ENGINE - LP COMPRESSOR - PROVIDE A PART NUMBER IDENTIFICATION FOR LPC MODULES THAT HAVE THE SIXTH STAGE BUFFER AIR CONFIGURATION REMOVED - CATEGORY CODE 6 - MOD.ENG-72-0149

V2500-ENG-72-0149

SERVICE BULLETIN

Reidentification of the new module identification plate
Fig.1

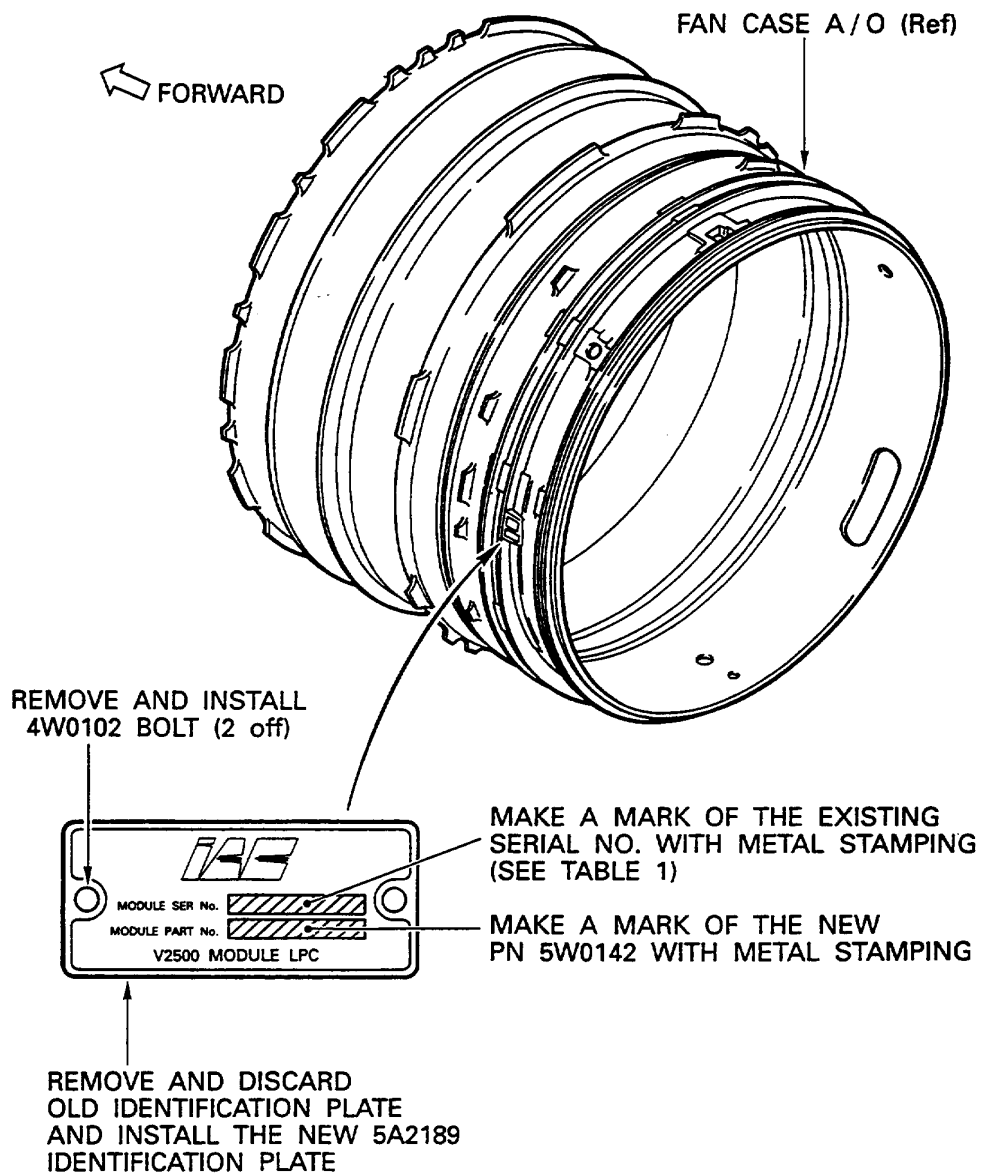
- (1) Find the existing Module Identification Plate which attach the Fan Case A/O (Refer to Figure 1).
- (2) Install the new 5A2189, Module Identification Plate as follows (Refer to Figure 1);
 - (a) Remove the two bolts and existing module identification plate.
 - (b) Prepare the new 5A2189, module identification plate.
 - (c) Make a mark of the new serial number and part number on to the new module identification plate by the approved procedures in References (3), Chapter/Section 70-09-00, Marking of parts, and refer to Table 1.
 - (d) Install the marked new module identification plate with the two 4W0102, bolts in to sufficient position.
 - (e) Torque the bolts to 36 to 45 lbfin (4,00 to 5,00 Nm).
